**DeKalb County Department of Planning & Sustainability**

**STAFF ANALYSIS**

**Case No.:** SLUP-22-1245550 **Agenda #:** N5  
**Location/Address:** 1799 & 1805 Clairmont Road **Commission District:** 2 **Super District:** 6  
**Parcel ID:** 18-103-03-017, -018  
**Request:** Request for a Special Land Use Permit (SLUP) to allow a drive-through (health services clinic) in the NS (Neighborhood Shopping) Zoning District.  
**Property Owner(s):** Viral Solutions  
**Applicant/Agent:** Ryan D. Jones, PE  
**Acreage:** 0.64 acres  
**Existing Land Use:** Office  
**Surrounding Properties:** To the north of the subject property are a residential parcel and an office use, to the south are medical office uses, to the west is a gas station use, and to the east are townhomes.  
**Comprehensive Plan:** CRC (Commercial Redevelopment Corridor)

# Site Plan

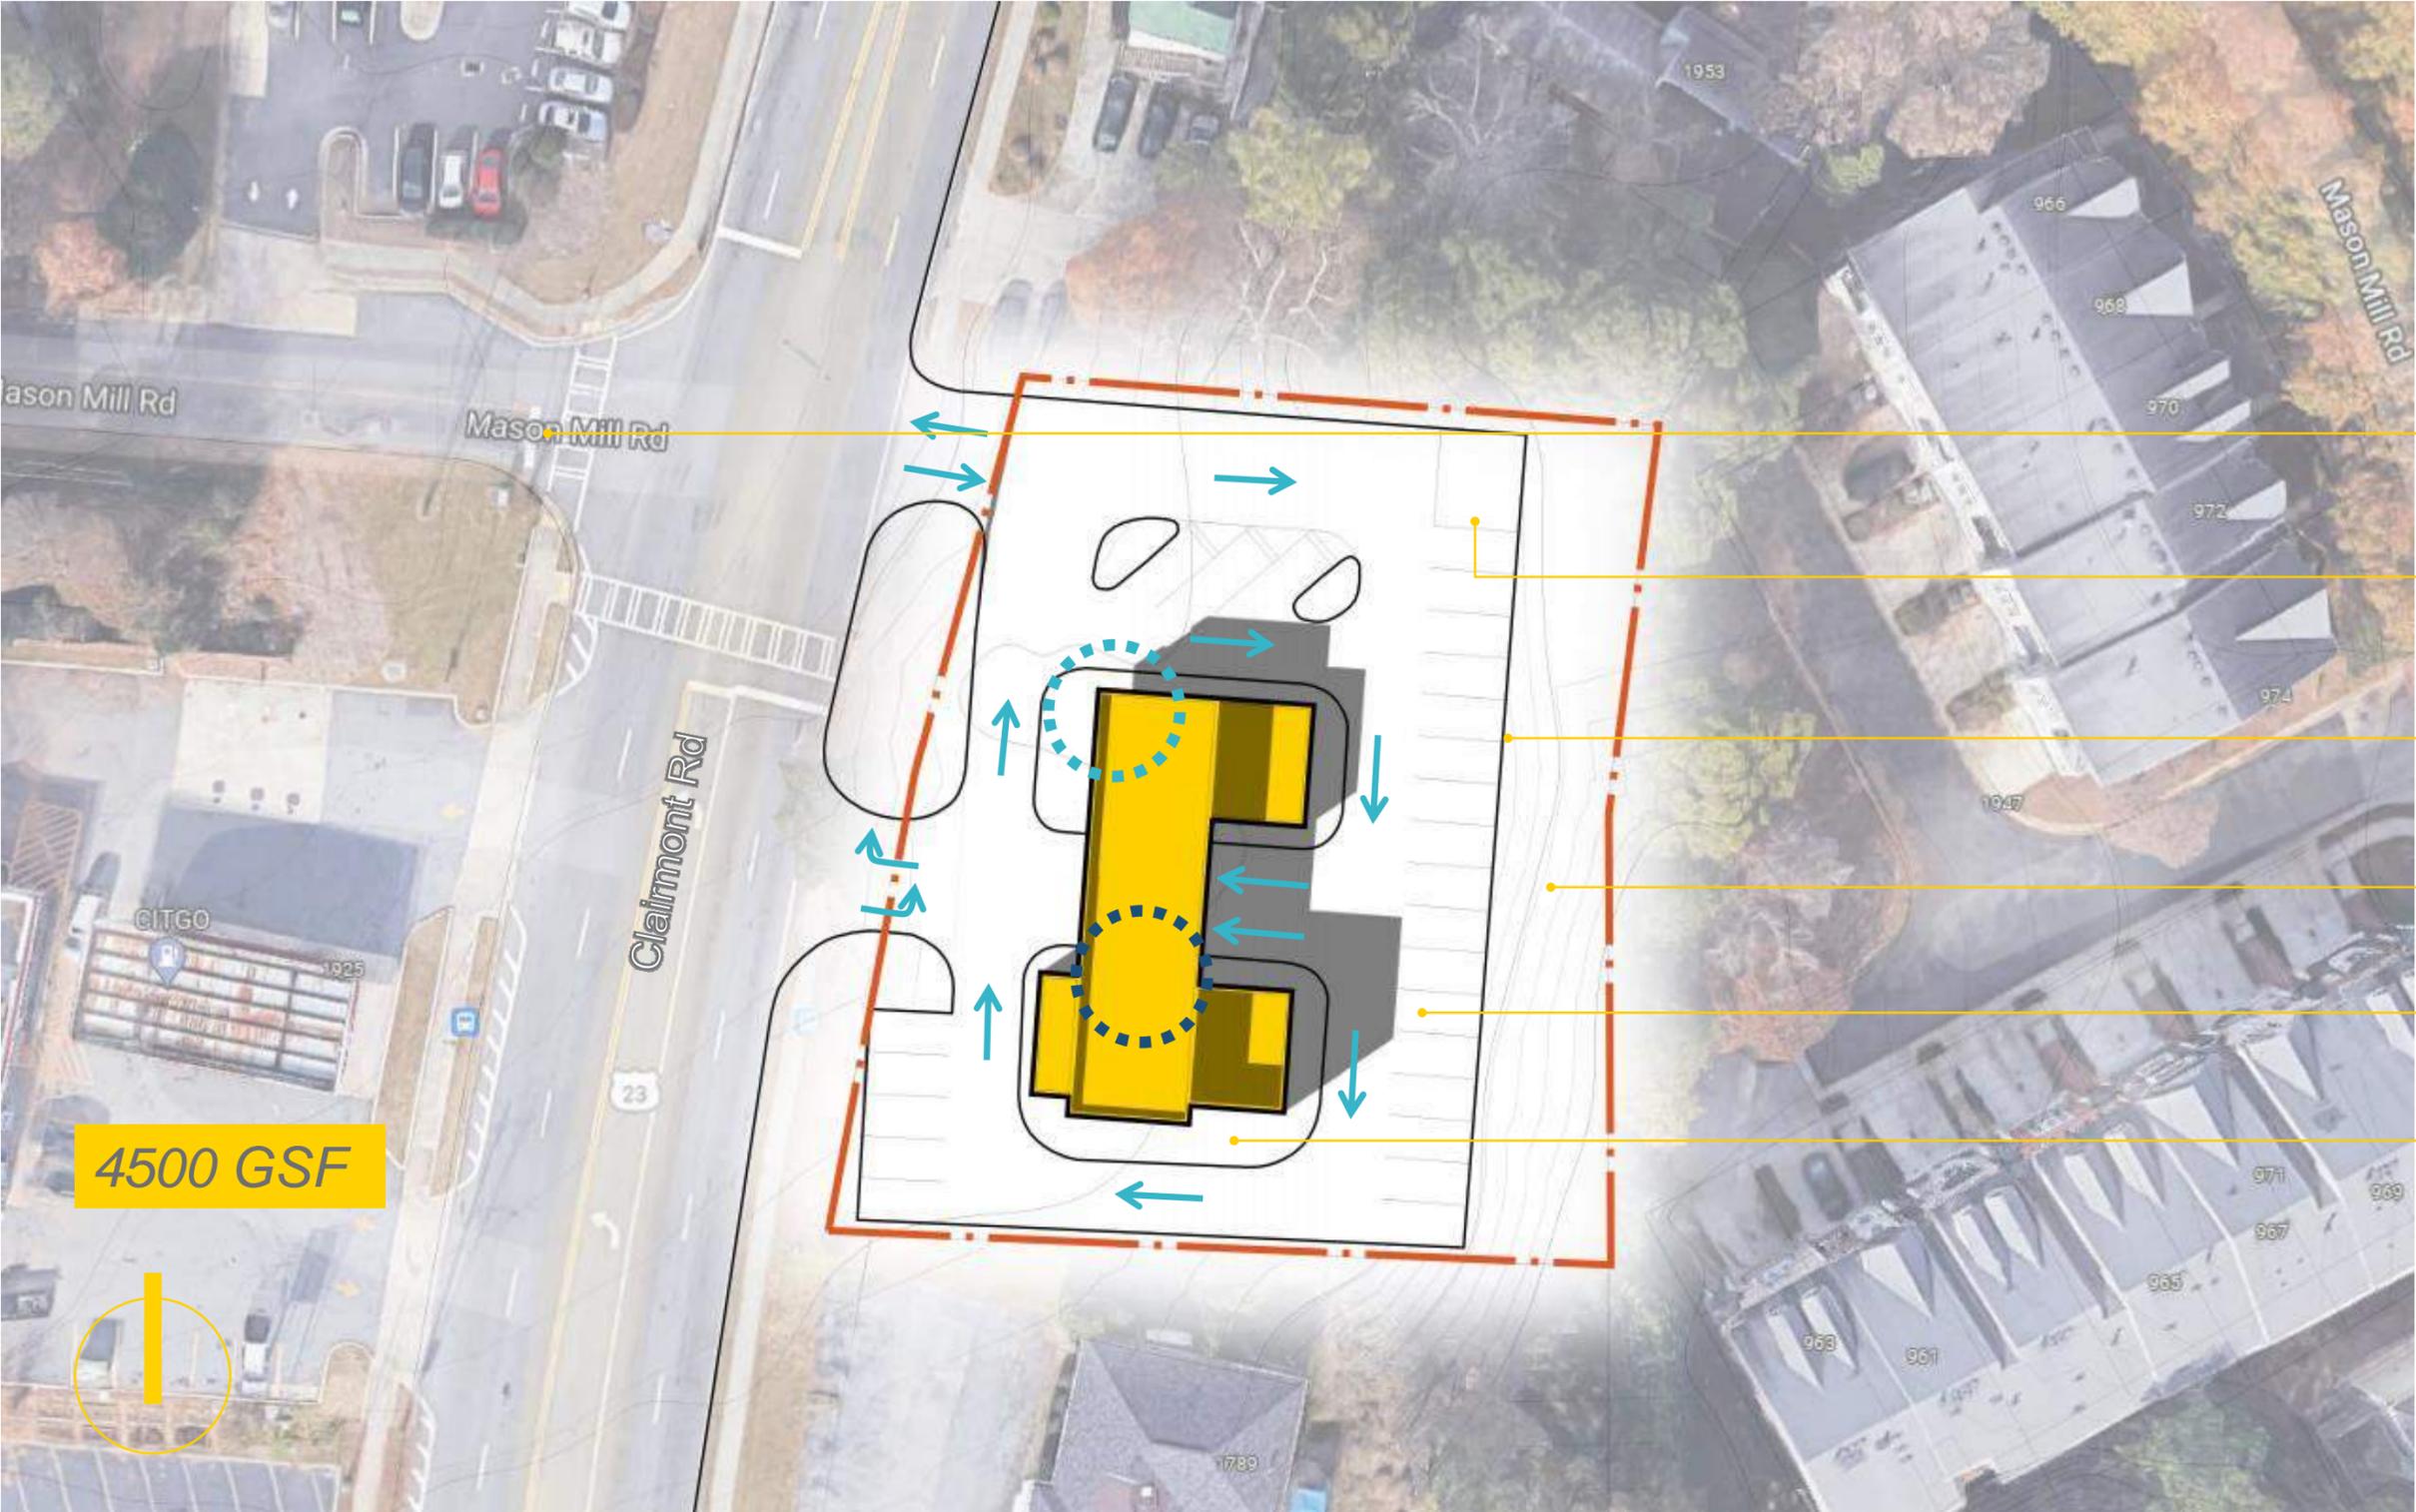
The subject properties are located near the intersection of Clairmont Road and Mason Mill Road. The proposed northern point of ingress/egress into the site is situated at the intersection, however, it is aligned with Mason Mill Road. The proposed southern point of ingress/egress may not be permitted due to its proximity to the intersection along with existing traffic management features (e.g., turning lanes, traffic signals, stop bars, crosswalks, etc.). Secondly, visibility of traffic traveling northbound (i.e., south to north) appears to be limited from 1799 Clairmont Road when exiting the site due to the curvature and decline of the right-of-way.

Additionally, the proposed site plan indicates an intent to “to seek variance to eliminate buffer.” A 50-foot vegetated buffer is required adjacent to residentially zoned properties.

The subject properties are located near the intersection of Clairmont Road and Mason Mill Road. The applicant proposes to use the existing two, full access points of ingress/egress to/from Clairmont Road. The proposed northern point of ingress/egress into the site is situated at the intersection, however, it is aligned with Mason Mill Road. The proposed southern point of ingress/egress may not be permitted due to its proximity to the northern access and the intersection along with existing traffic management features (e.g., turning lanes, traffic signals, stop bars, crosswalks, etc.). Secondly, visibility of traffic traveling northbound (i.e., south to north) appears to be limited from 1799 Clairmont Road when exiting the site due to the curvature and decline of the right-of-way. Ultimately, the Georgia Department of Transportation (GDOT) will have to evaluate the proposed access management plan in conjunction with the County Public Works Department—Transportation Division. Moreover, the existing sidewalk along the property frontage will need to be upgraded and enhanced per the *Zoning Ordinance*.

The drive-through lane is proposed through the center of the structure. A variance will be required.

A 14.5-foot bypass lane is proposed.

**Conceptual plan doesn't indicate the location of the stormwater management facility. Concerns are related to the discharge point of the facility. Development/residences are located downstream of the property, and consideration must be given as to where the discharge pipe from the facility is directed as to not create adverse effects. Additional, design professional shall be aware that (1) per county codes, existing conditions must be taken as wooded for the hydrology analysis (meaning existing impervious is not to be considered) and (2) Reduction Reduction Volume is the default water quality.**

**Runoff Reduction Volume shall be provided, unless technical justification is provided as to the unfeasibility. Strongly recommend to investigate the site and identify location where RRv can be provided and re-design/revise the layout to comply with the RRv requirement.**
